WINSTAR Display Co.,Ltd.

Notification Subject: Engineering design change of FPC positioning holes

■ Issue Date: October 30, 2025

Before change	After change

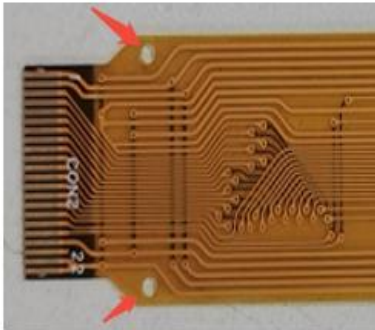
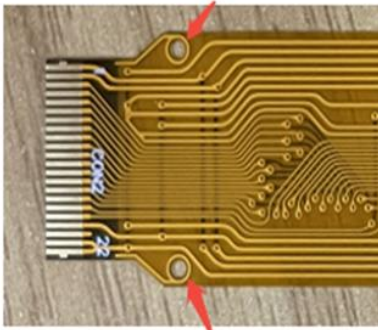
According to the latest design specifications, add copper foil ring to the FPC positioning holes to prevent them from being torn.

Switch to using the new version (Positioning hole with copper foil ring) after the current FPC stock is used up.
